SUBJECT: WATTS BAR NUCLEAR PLANT - RESPONSES TO RAI REGARDING
SPENT FUEL POOL COOLING ANALYSIS METHODOLOGY (TAC NO. MB1884)

ENCLOSURE 1
TENNESSEE VALLEY AUTHORITY
WATTS NUCLEAR PLANT (WBN)
UNIT 1
DOCKET NO. 390

RESPONSES TO NRC REQUEST FOR ADDITIONAL INFORMATION

FIGURE 1

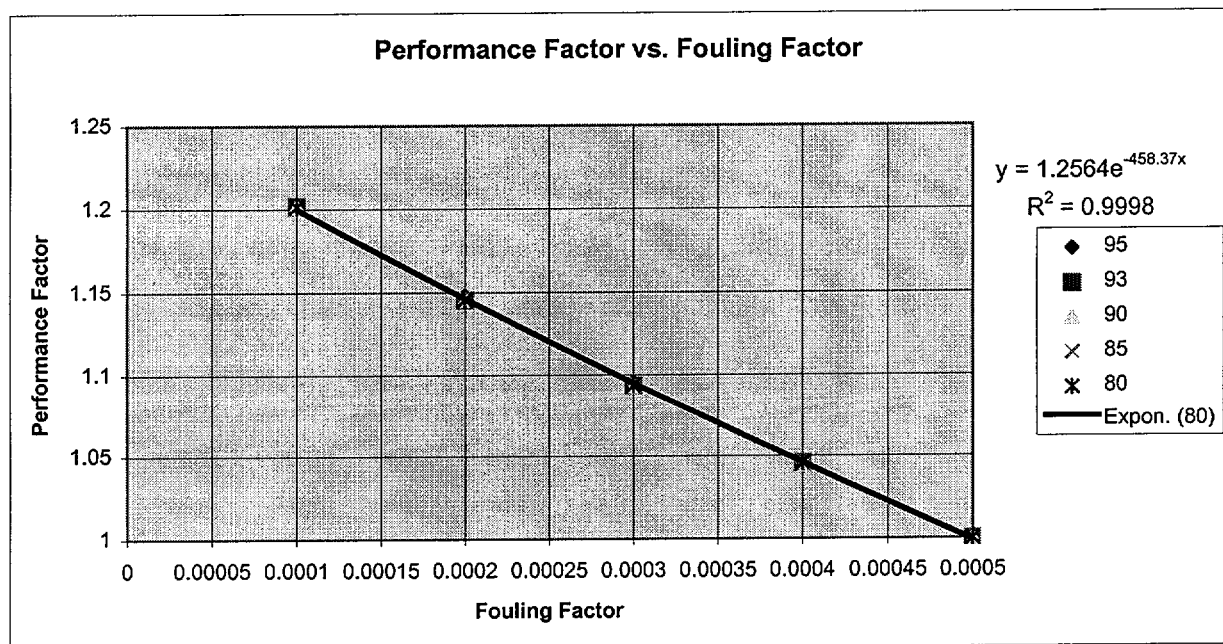
1. TVA states in Section III of Enclosure 1 "Proposed Methodology Change - Description and Evaluation of the Proposed Change" that "Analyses have been performed that support the proposed change." Please provide these analyses or a summary of these analyses, including the methodology (e.g., equations, code, how to determine heat exchanger heat removal capability, etc.), important assumptions and results.

The following figure depicts the relationship of Performance Factor to fouling factor, and also shows the independence of fouling factor to changes in CCS temperature. Note that all data for varying CCS temperature from 95°F to 80°F is superimposed on the graph as shown in Figure 1, clearly demonstrating that the performance factor for fouling is independent of CCS temperature.
